Comments on the Town of Sussex Flood Mitigation Project Plan

Presented to the Impact Assessment Agency of Canada

Re: The Sussex Flood Mitigation Project – IAAC Ref. 89179

Figure 1: Top left - present day 1-in-20-year flood event; top right - present day 1-in-100-year flood event; bottom left – 1-in-20-year flood event in the year 2100 adjusted for climate change; bottom right – 1-in-100-year flood event in the year 2100 adjusted for climate change.

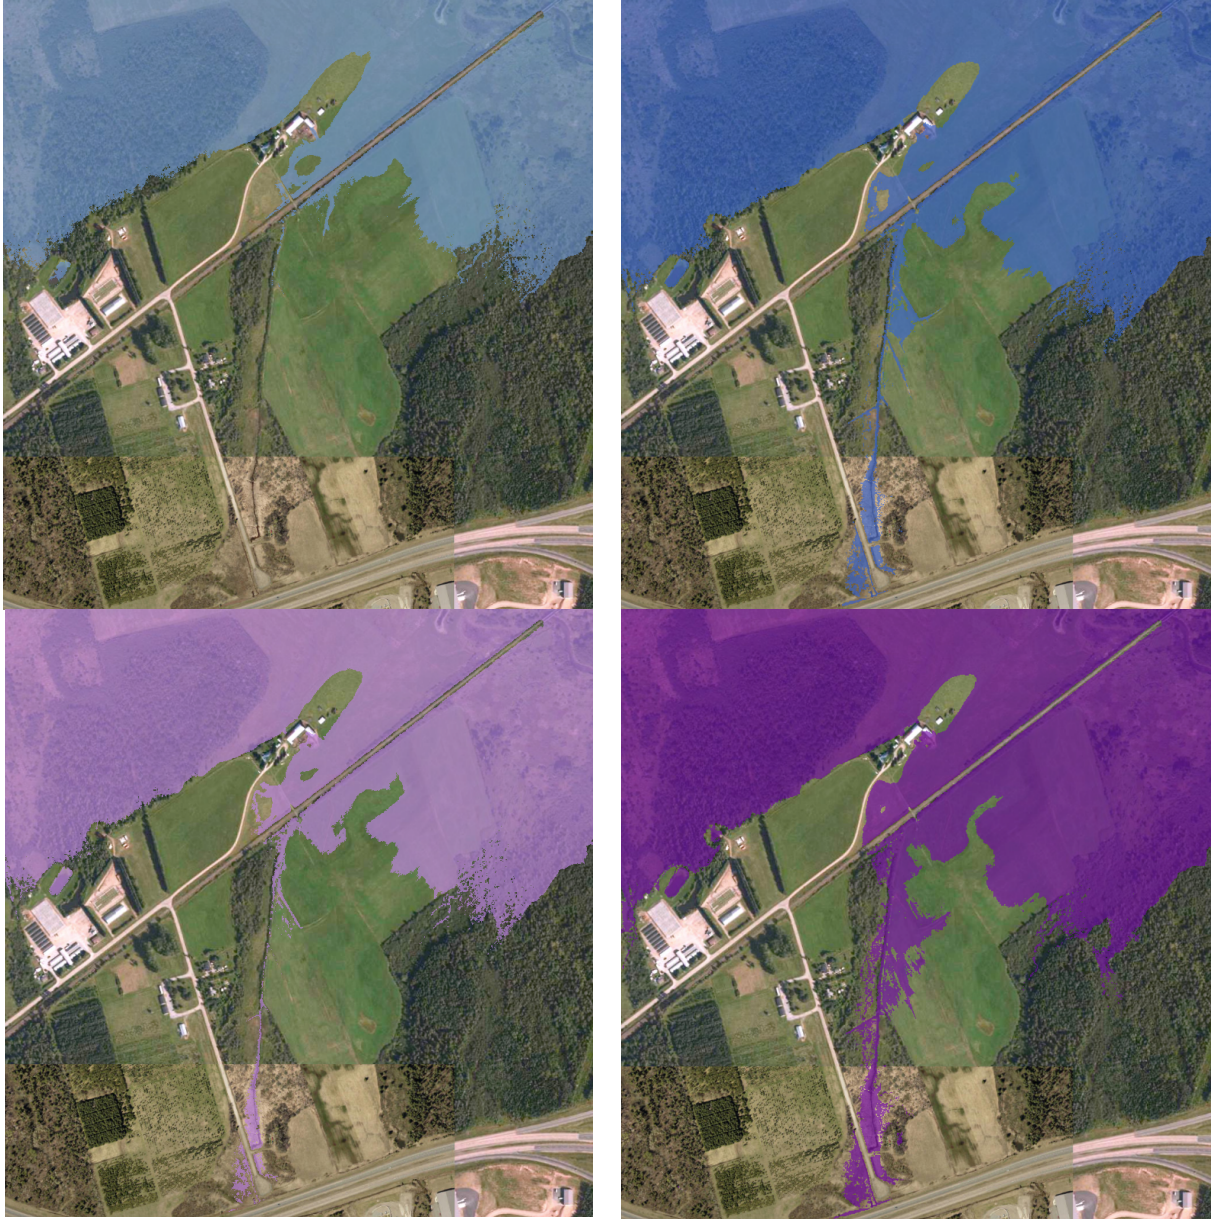
While some minor flooding effects are notable in the scenarios presented in Figure 1, present day 1-in-100-year flood events do not impact the majority of the area used for agricultural and residential purposes. With an additional flow of approximately 3.5 million gallons per minute flowing from the proposed outlet, the adjacent land will inevitably experience increased flooding. This would artificially create a flood plain in an area where one does not currently exist.

Figure 2: Elevation mapping of the proposed Trout Creek diversion channel area indicating flow of diverted water will follow the known watercourse north of the outlet (excerpt from the March 30, 2022 presentation).

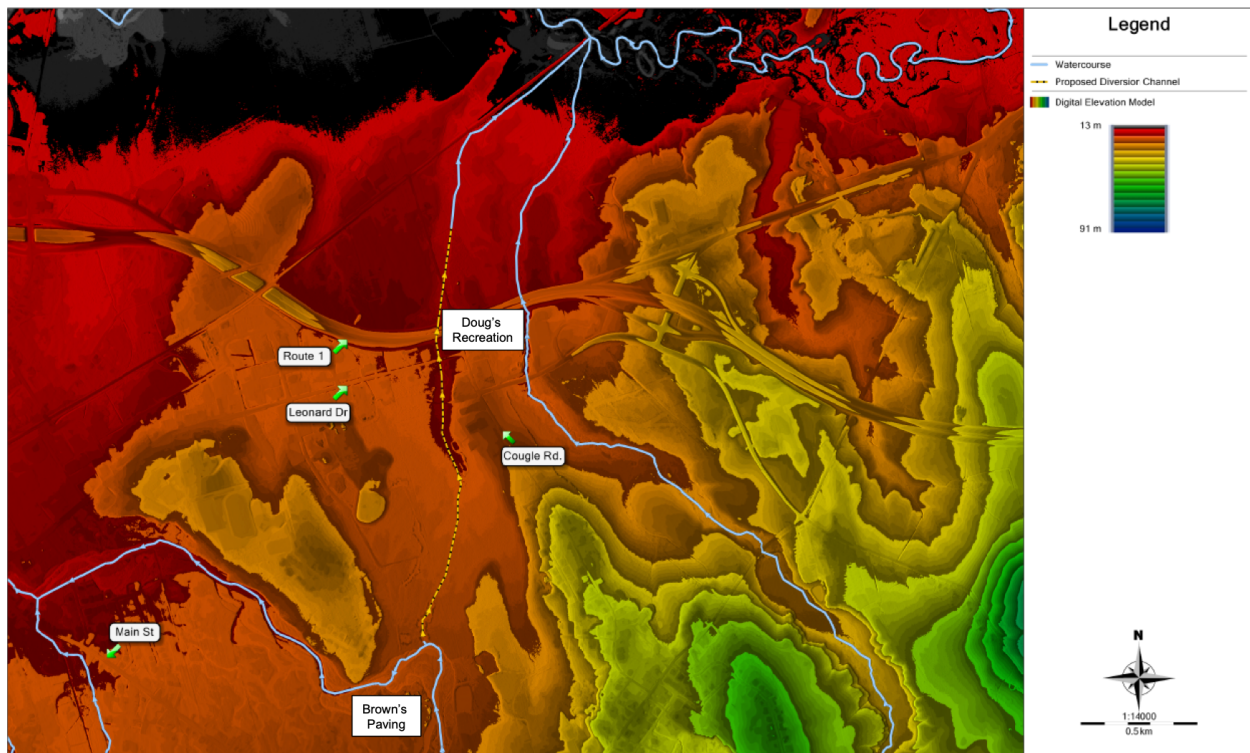
The proponent has also indicated that a known watercourse will carry flood waters from the diversion channel outlet to the Kennebecasis River flood plains (see Figure 2). The watercourse being referenced is a small brook that would not be reasonably believed to carry the proposed volumetric flow of water from the diversion channels to the Kennebecasis flood plains without additional impacts of flooding onto adjacent properties. Further information from the proponent should be supplied to indicate how the watercourse is integrated into the overall design considerations for the diverted waters.

Figure 3: Excerpt from September 10, 2020 slideshow from the Town of Sussex website. Note the lack of flood modelling extending beyond town limits to the north and west (including the upstream and downstream portions of the Kennebecasis River).

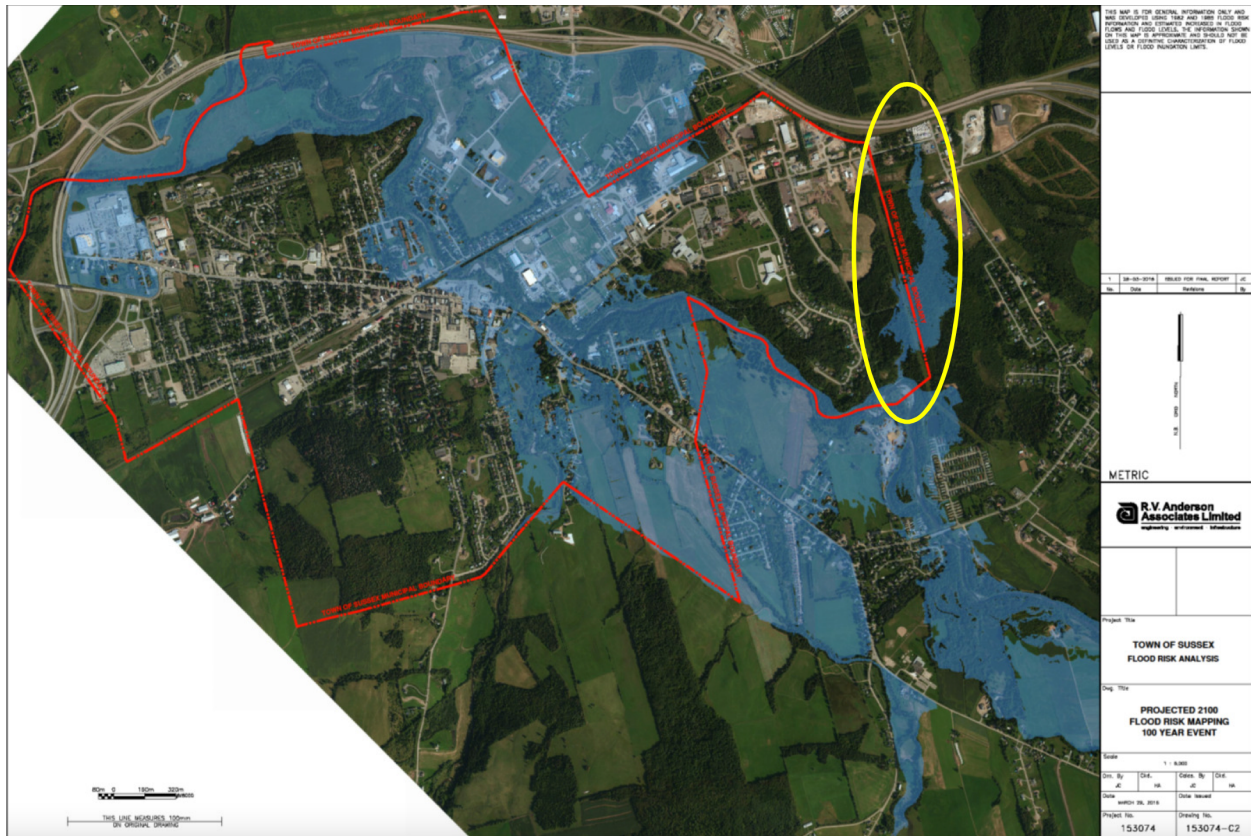
While it also may be accurate that public sessions were held by the proponent, the presentation from September 10, 2020 included graphical representations of the flood modeling completed. The extents of the flood model did not reach beyond Town limits, suggesting the flood mitigation measures did not have any potential consequences to residents outside of the Town.

Figure 4: Screenshot from Service New Brunswick online property assessment website. The former McLeod Drive landfill site is highlighted in red.

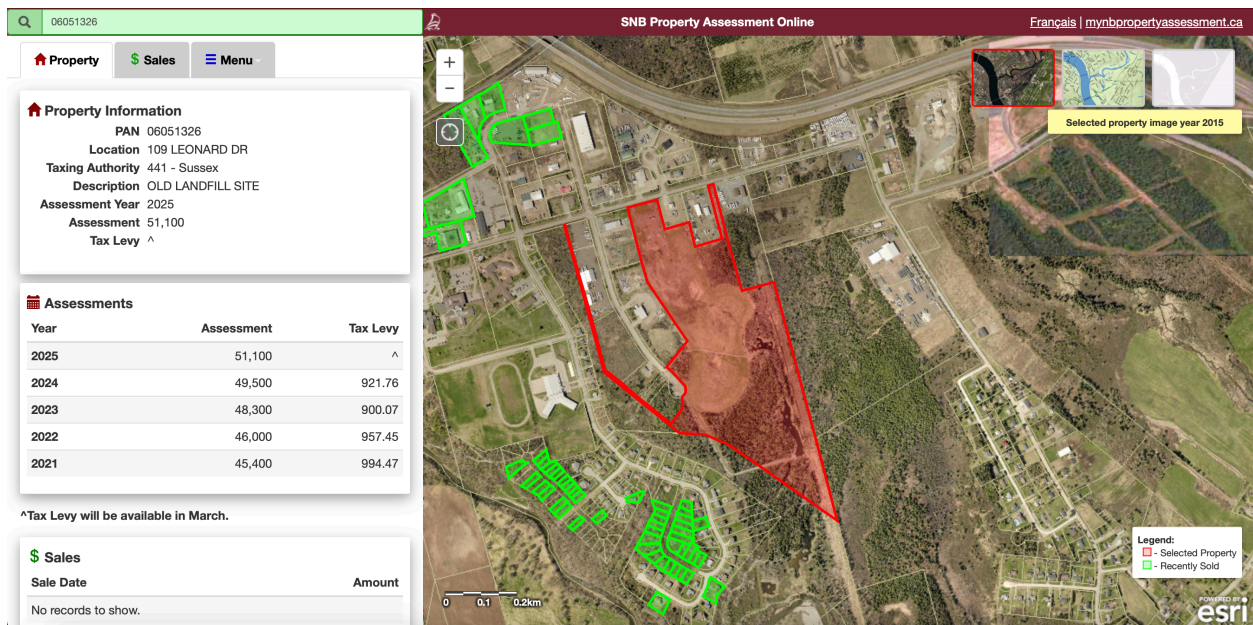
- The former McLeod Drive landfill site (PID# 30011001) shown below in Figure 4.
 - o Historic landfill that has been closed and capped (dates of operation not precisely known at time of writing).

- o The former landfill site is approximately 50 m (160') from the proposed Trout Creek diversion channel location according to GeoNB parcel data and Figure 4 of Appendix A in the proposal.

- o Given the timeframe during which the landfill was operational, the lack of environmental stewardship considered acceptable at the time, and the various metals and chemicals that were widely available for consumer purchase and use (and ultimately disposal), additional study should be completed to ensure transport of potentially harmful substances to downstream receptors does not occur.

- o A thorough screening should be done for any potential contaminants of concern (as assessed by a Site Professional) including bioaccumulative substances and environmentally persistent contaminants.

Figure 6: Screenshot of GeoNB with PID# 30125207 highlighted. DTI garage and associated properties located south of highlighted property. Flood risk mapping shows flood waters currently encroach on these properties and Gazette Status indicates "Additional Information Exists."

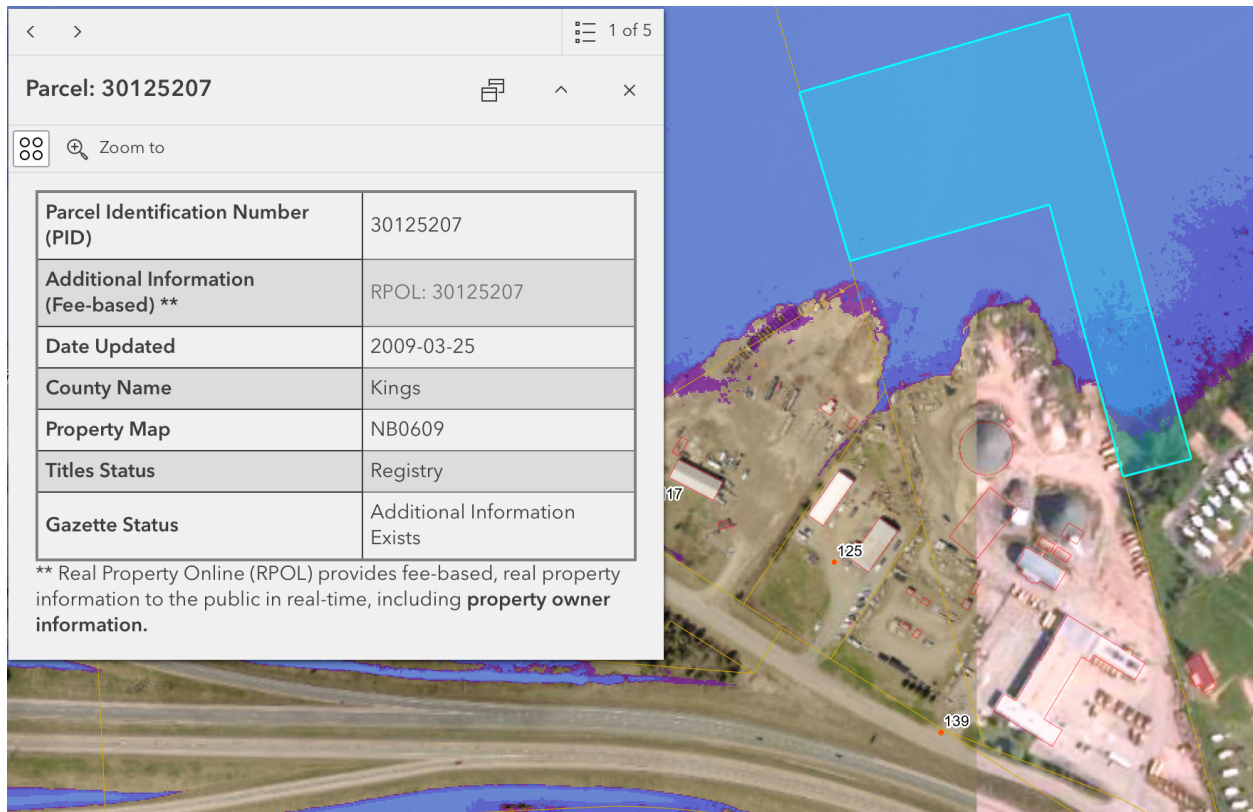
- Provincial Department of Transportation and Infrastructure (DTI) garage and adjacent lots (PID# 00204925, 30073589, and 30125207). See Figure 6 below.

- GeoNB flood risk mapping indicates that portions of the properties are currently at risk of flooding.
 - Records obtained from Service New Brunswick indicate N.B. Transportation as the owner of PID# 30125207 and Land Gazette data indicates that PID# 30125207 had a land notice published related to site remediation as assigned by the New Brunswick Department of Environment and Local Government on October 7, 2021.

- Potential presence of oil-water separator for garage floor-drains.
 - Road salt storage domes present could pose additional risk of salt run-off.
 - Above-ground petroleum storage tanks are present. Petroleum storage tanks and associated infrastructure (current and historical) should be evaluated to ensure no added risk of contaminant transport and/or accidental release exists.

Figure 7: View of "Four Corners" intersection on GeoNB with overlay of flood risk models. Properties on each corner of the intersection have current models showing encroaching flood waters.

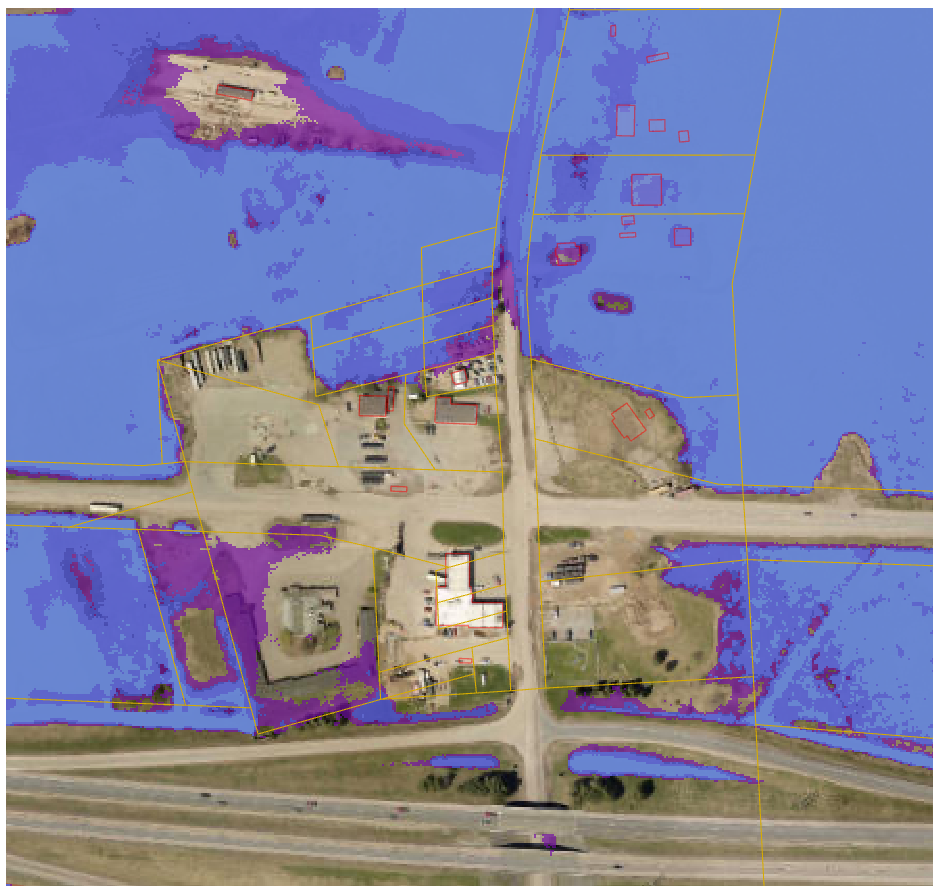
- o GeoNB flood risk maps indicate flood waters encroach on several of these properties (see Figure 7).
 - o Fuel retail systems often have issues with leaking underground infrastructure including underground storage tanks (USTs), petroleum product piping, and oil-water separators for stormwater treatment.

- o Oil-water separator (if present) should be assessed by a professional engineer to determine that no negative impacts would result from increased stormwater influent volumes (due to increased flood water elevations) so as not to exceed the systems design capacity to handle storm water and result in the release of accumulated LNAPL from within the system.

Figure 8: Property associated with truck wash operation.

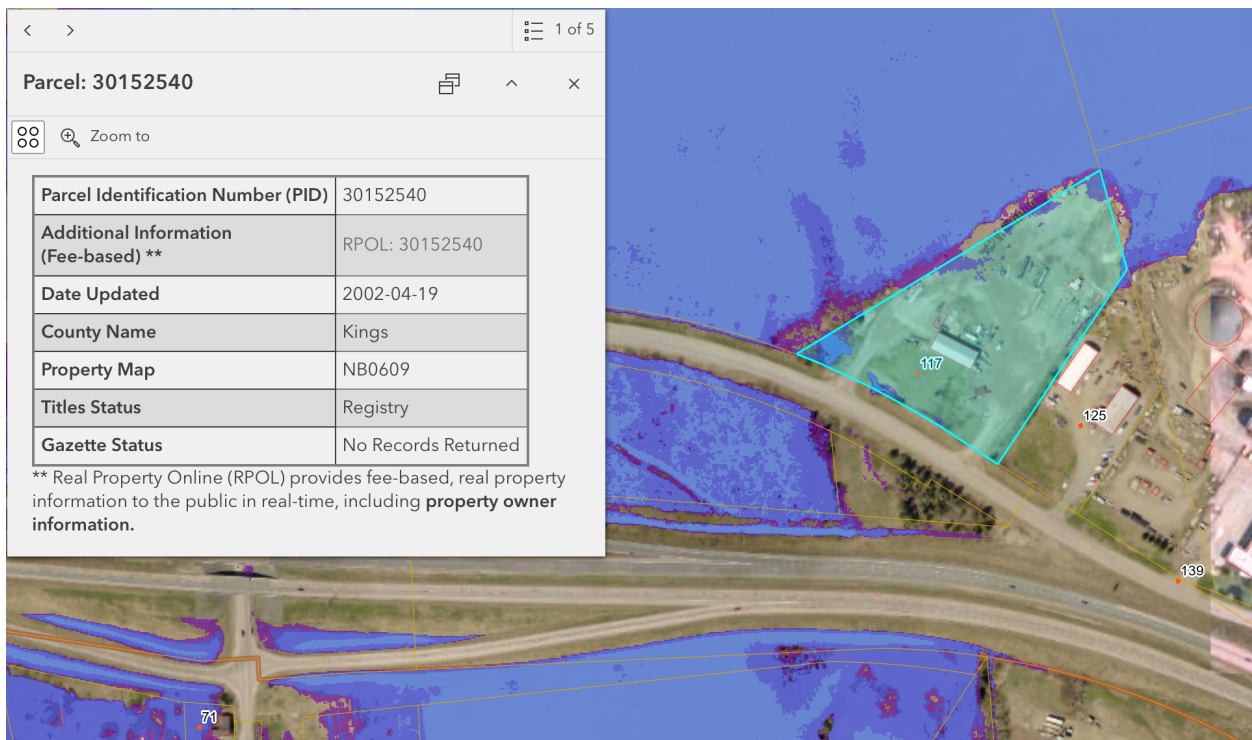
- Property associated with truck wash facility (PID# 30152540)
 - o GeoNB flood risk mapping indicates flood waters may encroach on this property.
 - o Equipment washing facilities often use degreasers and surfactants to remove grease and oil from equipment.
 - o Potential presence of oil-water separator and/or wash water treatment equipment which may need evaluating.
